The Commission has issued the enclosed Amendments Nos. 119, 119, and 116 to Licenses Nos. DPR-38, DPR-47 and DPR-55 for the Oconee Nuclear Station, Units Nos. 1, 2 and 3. These amendments consist of changes to the Station's common Technical Specifications (TSs) in response to your request dated November 12, 1982, as supplemented on February 24, 1983.

These amendments revise the TSs concerning the heatup, cooldown and inservice test limitations for the reactor coolant systems of each Oconee unit.

OCONEE NUCLEAR STATION, UNIT NO. 1

SAFETY EVALUATION BY THE OFFICE OF NUCLEAR REACTOR REGULATION
SUPPORTING AMENDMENT NO. 119 TO FACILITY OPERATING LICENSE NO. DPR-38

UNIT 1 OCONEE NUCLEAR STATION
 REACTOR COOLANT SYSTEM NORMAL OPERATION-HEATUP
 LIMITATIONS APPLICABLE FOR THE FIRST 15 EFY

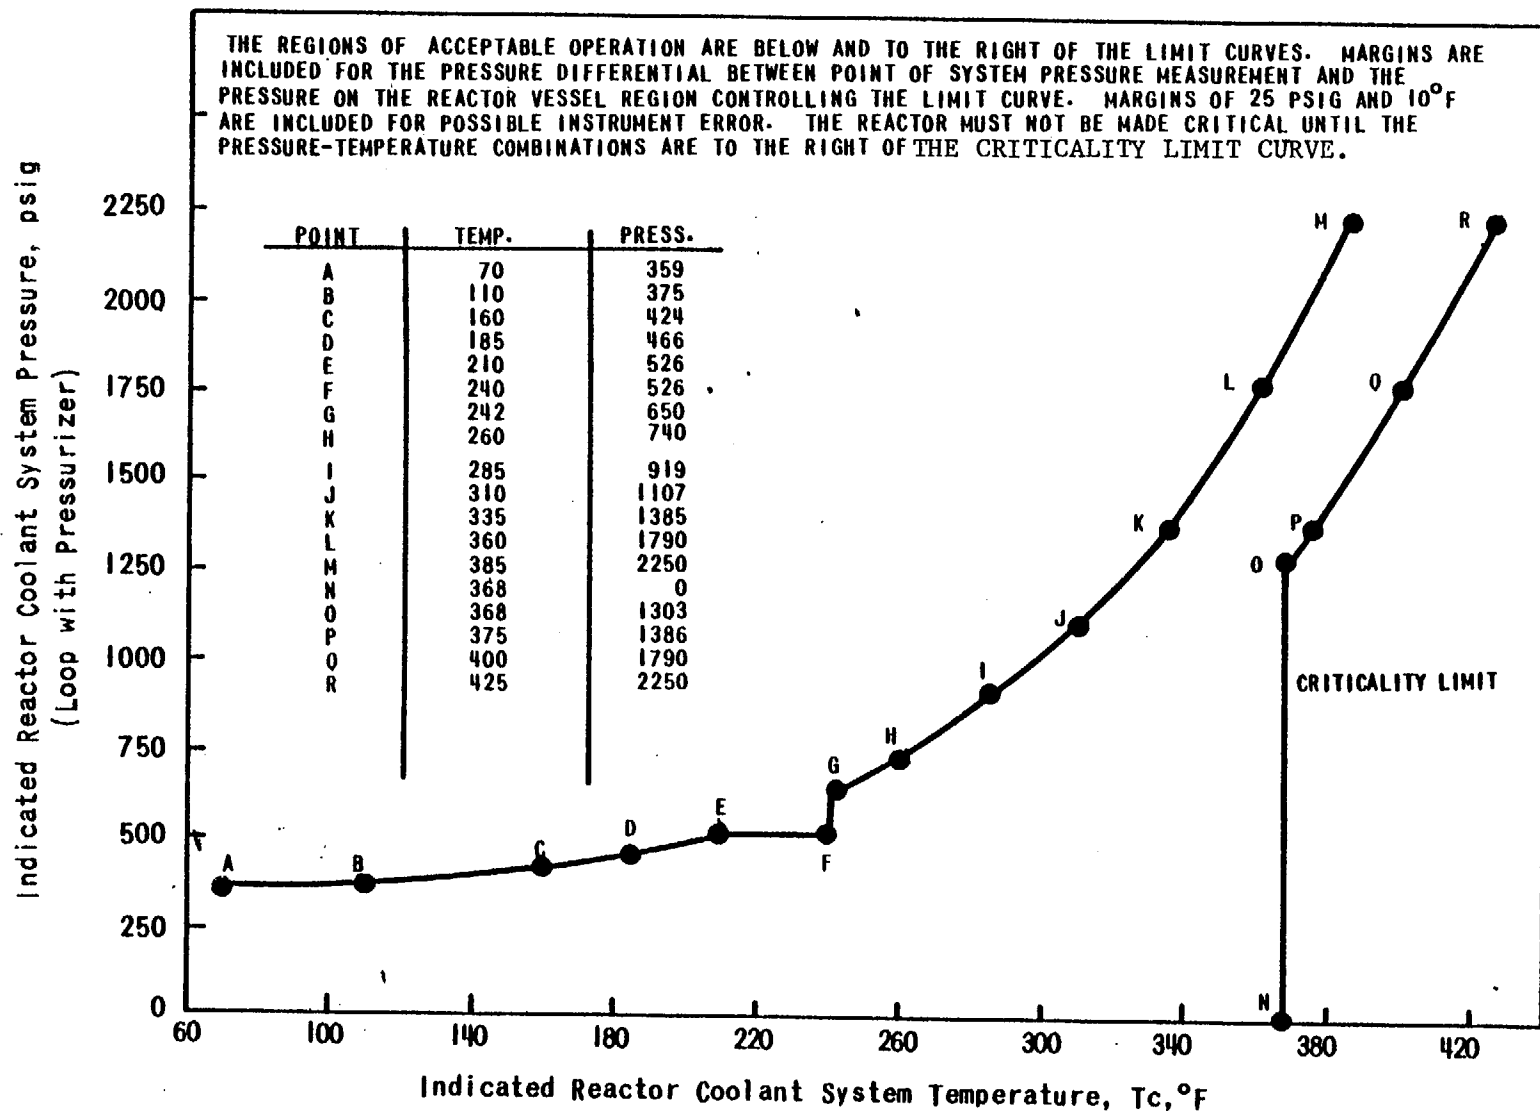
Heatup rates and allowable combinations of pressure and temperature shall be limited in accordance with Table 3.1-1 and Figure

3.1.2-1A Unit 1

Figure 3.1.2-1A

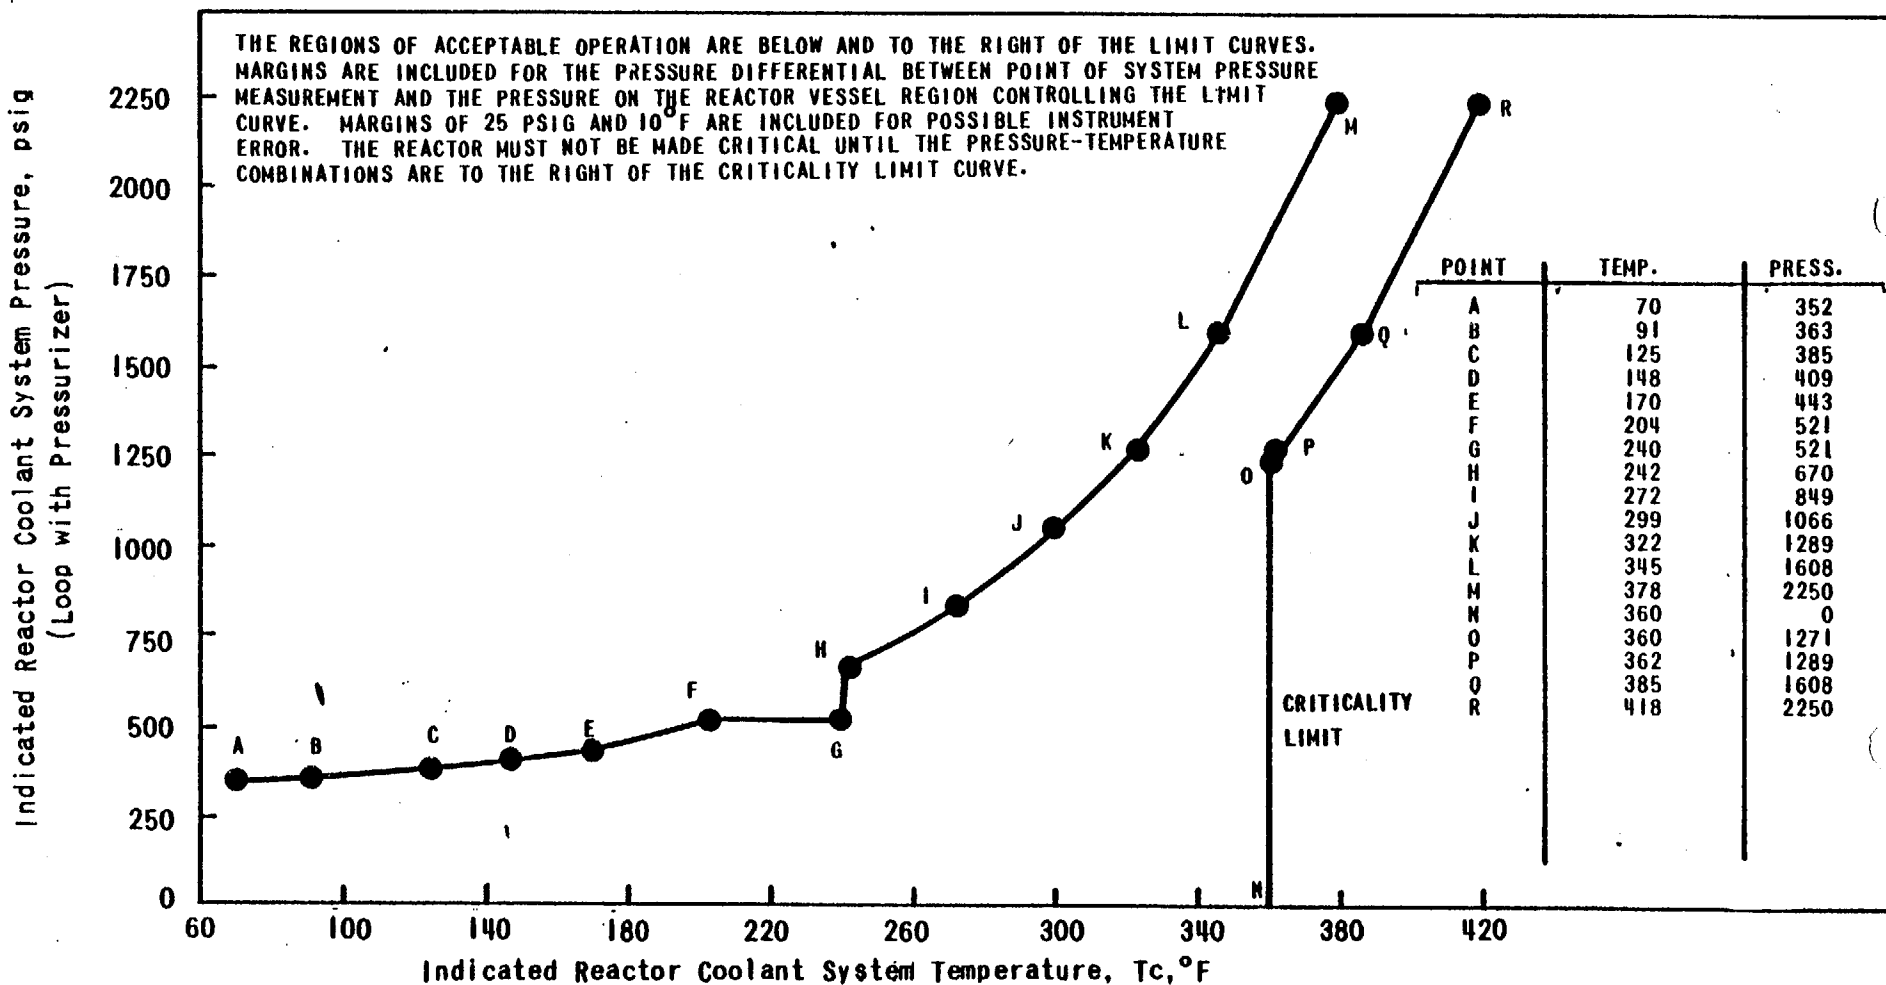
3.1.2-1B Unit 2

Figure 3.1.2-1B

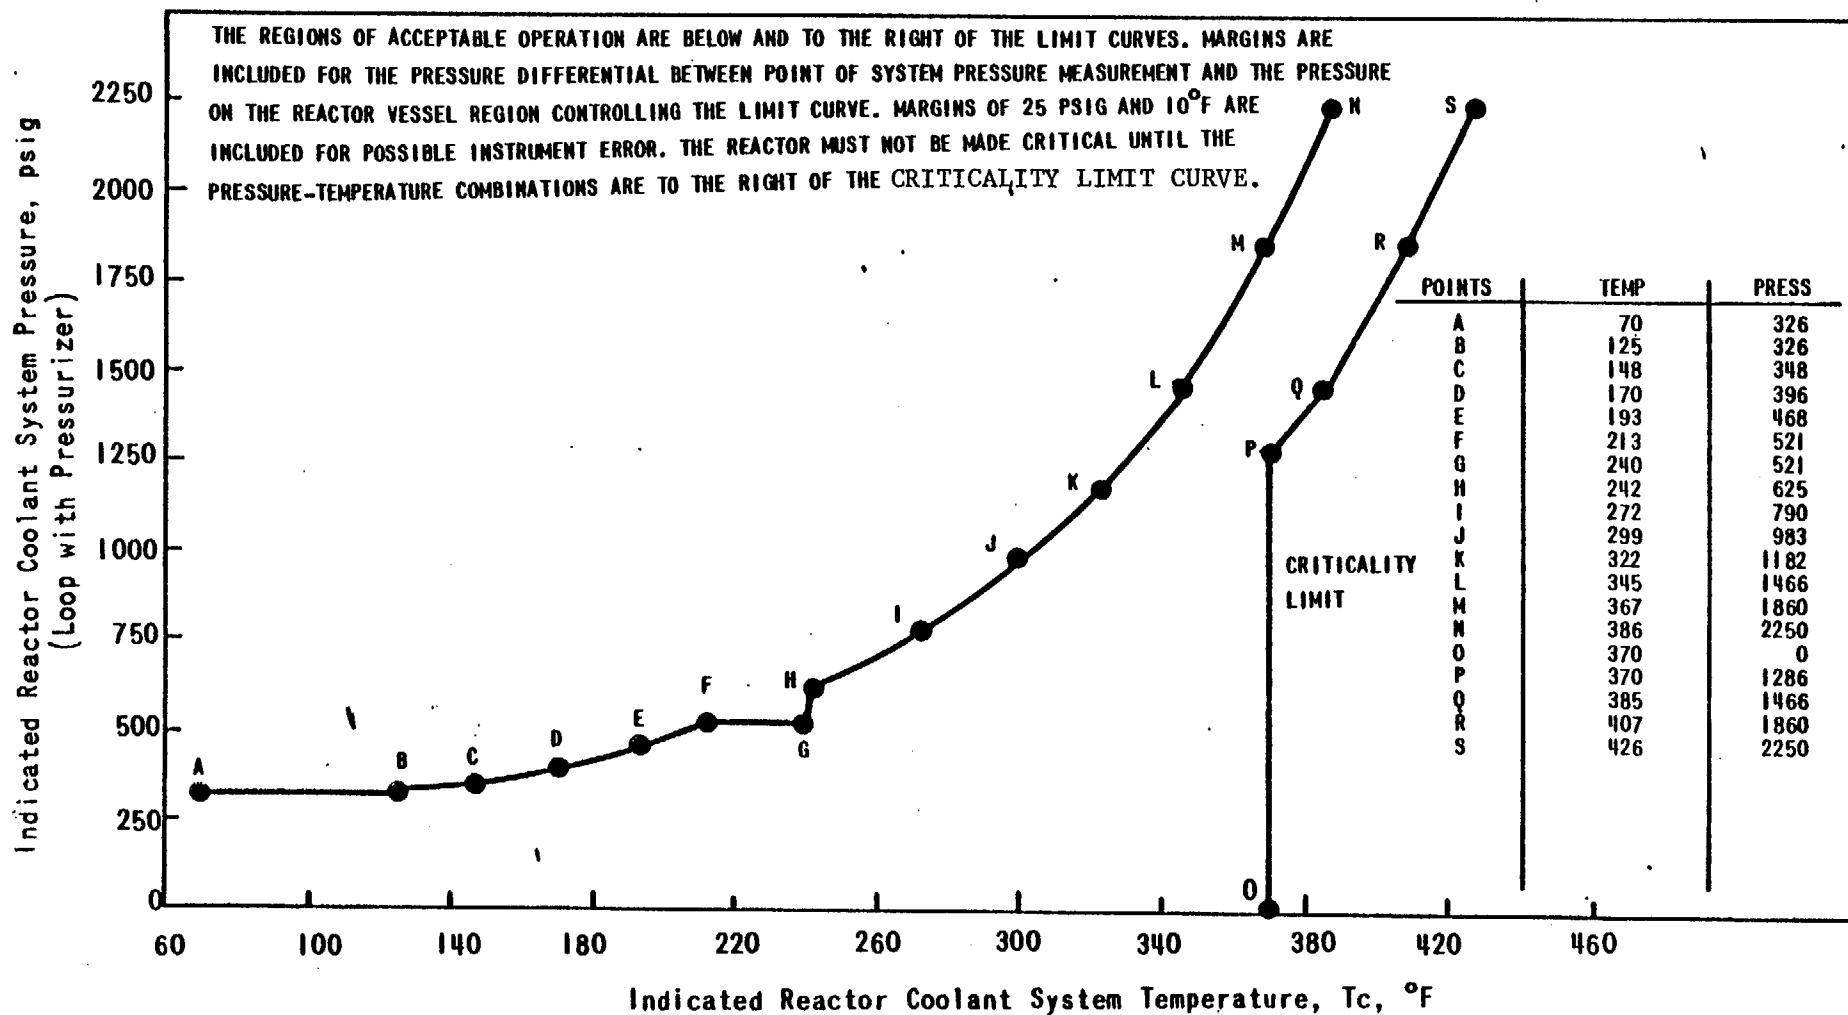
3.1.2-1C Unit 3

Figure 3.1.2-2A

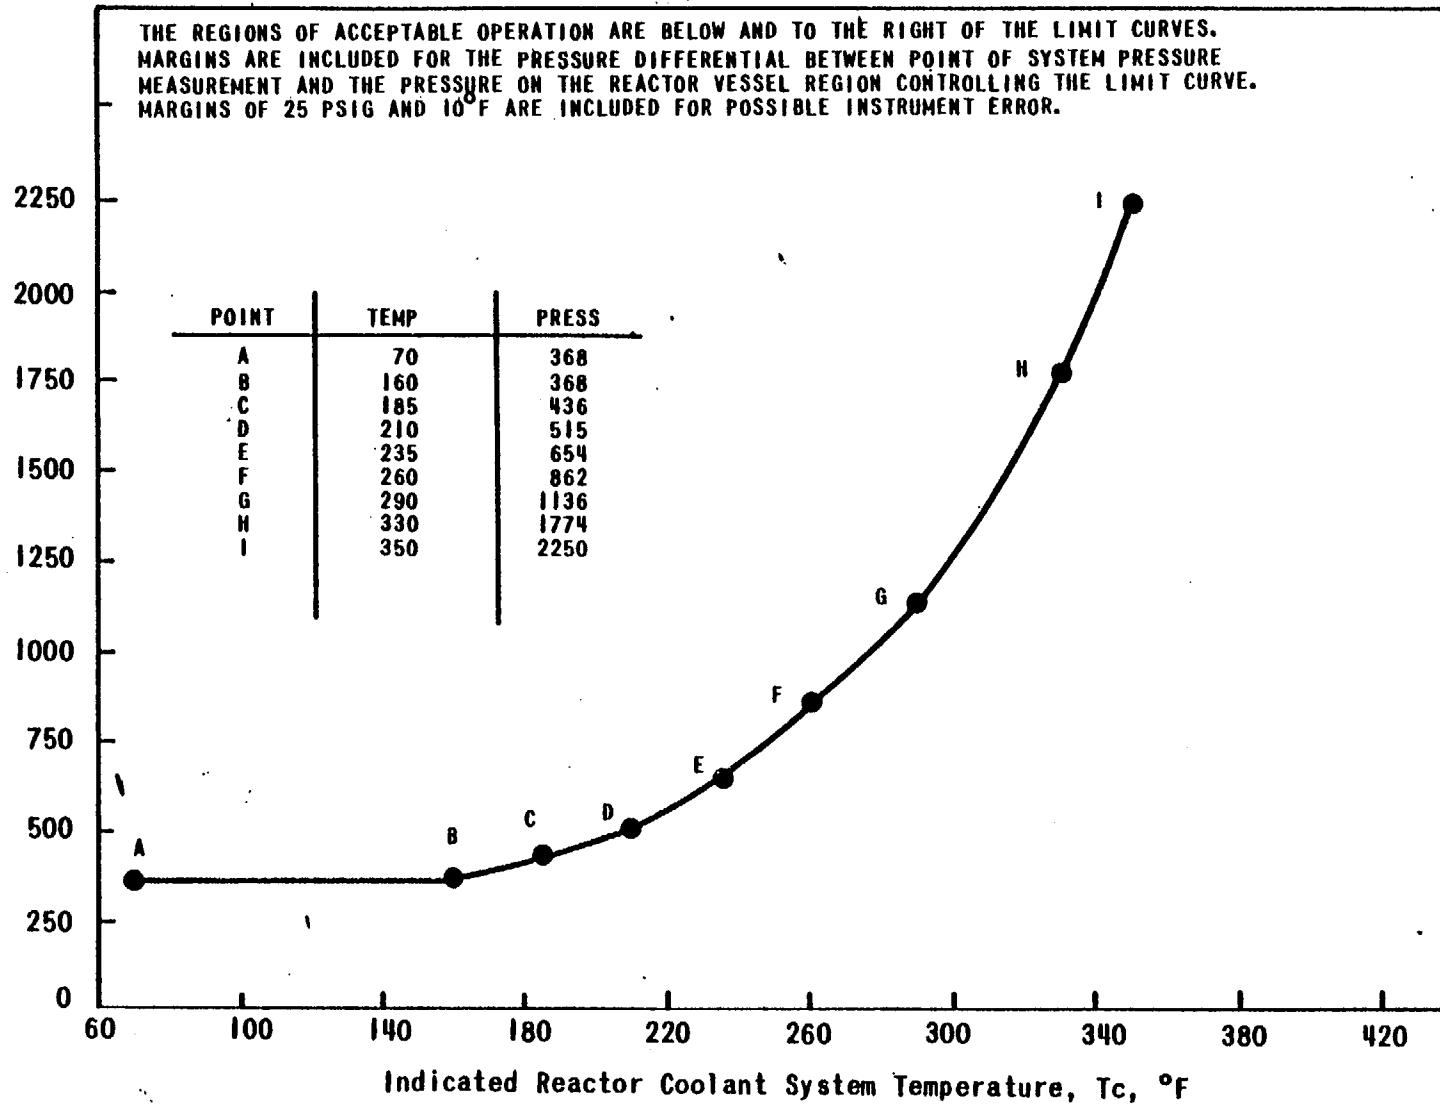
Cooldown rates and allowable combinations of pressure and temperature shall be limited in accordance with Table 3.1-2 and Figure

3.1.2-2A Unit 1

UNIT 1 OCONEE NUCLEAR STATION
REACTOR COOLANT SYSTEM NORMAL OPERATION-
COOLDOWN LIMITATIONS APPLICABLE FOR
FIRST 15 EFY

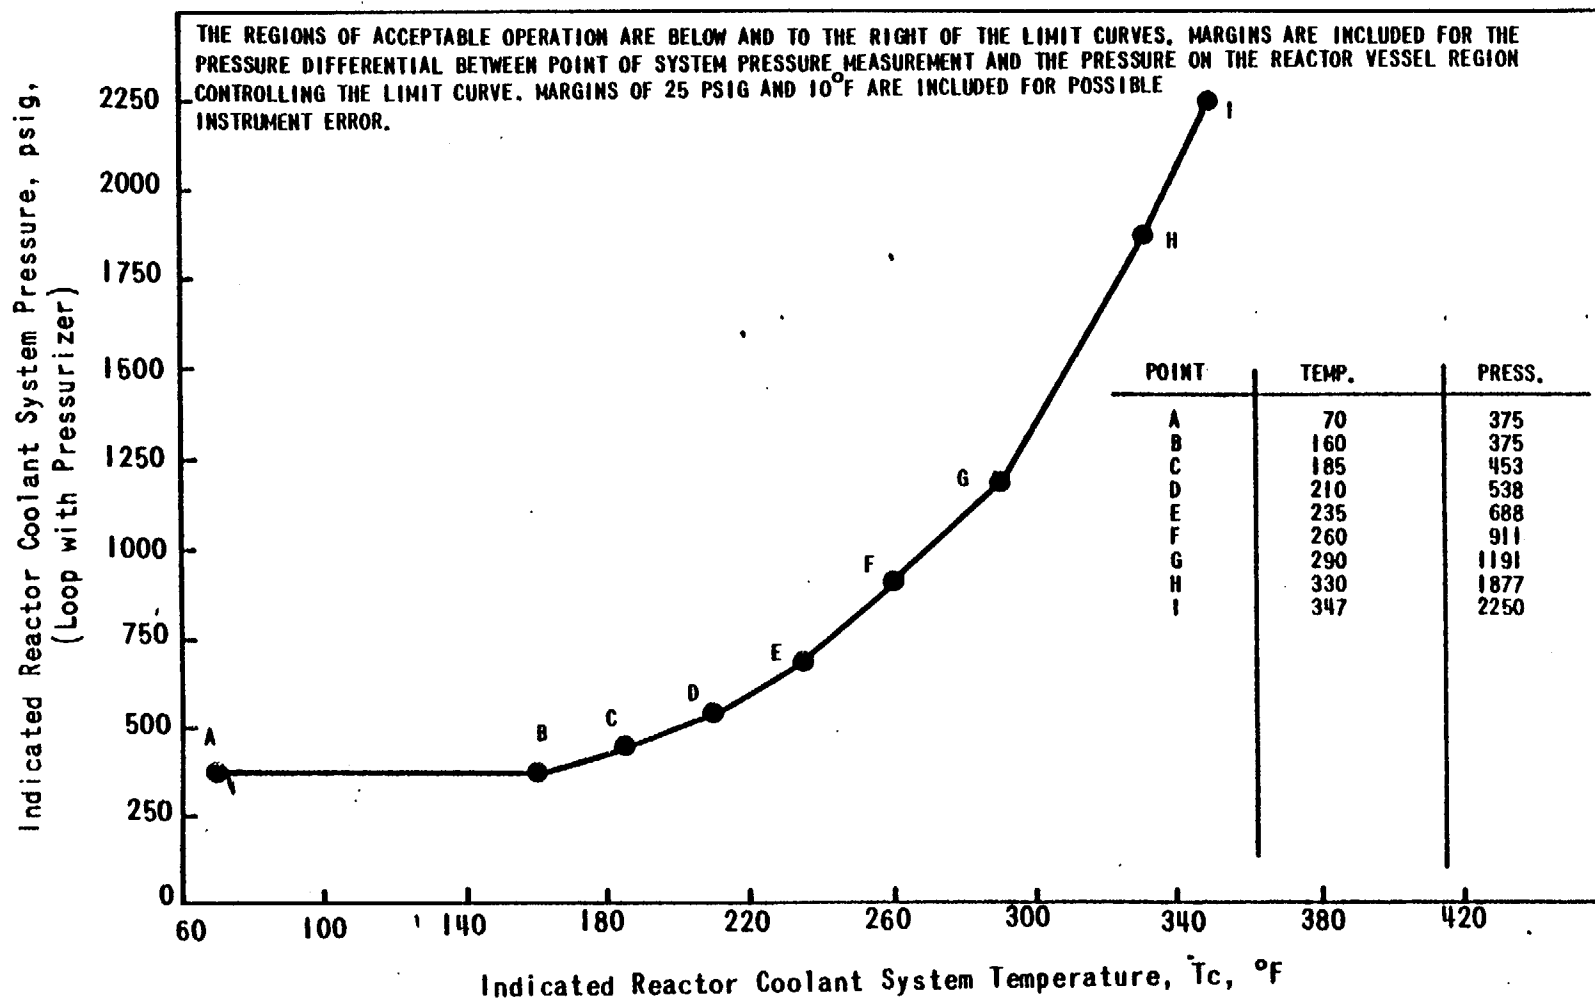
3.1.2-2B Unit 2

Figure 3.1.2-2B

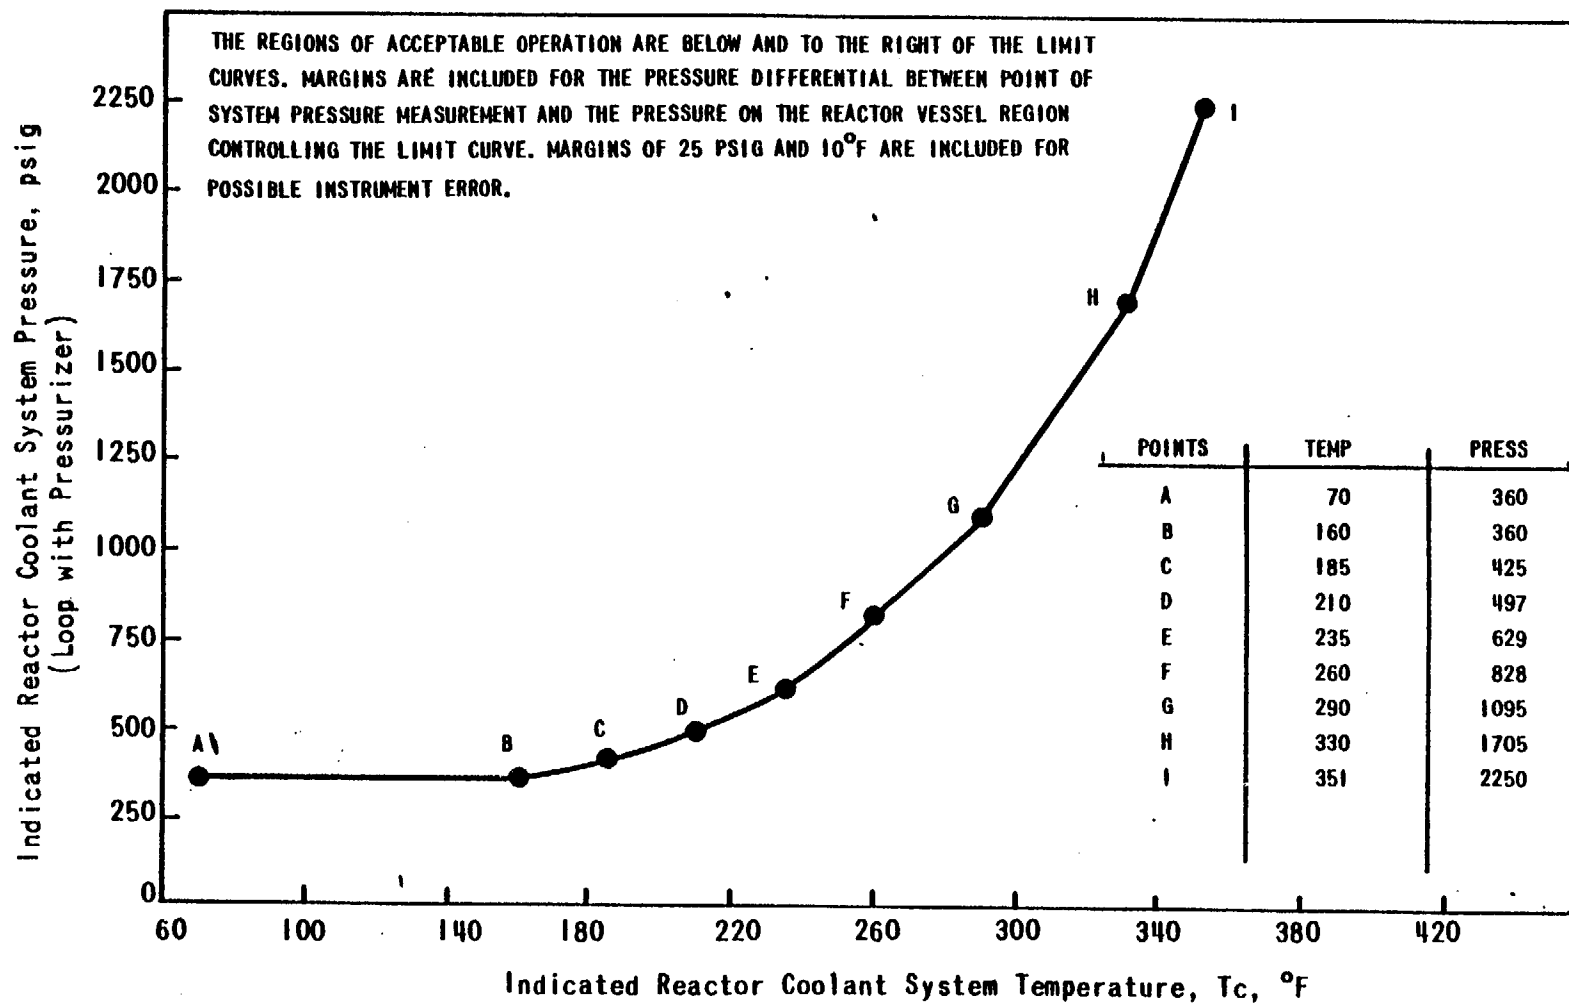
3.1.2-2C Unit 3
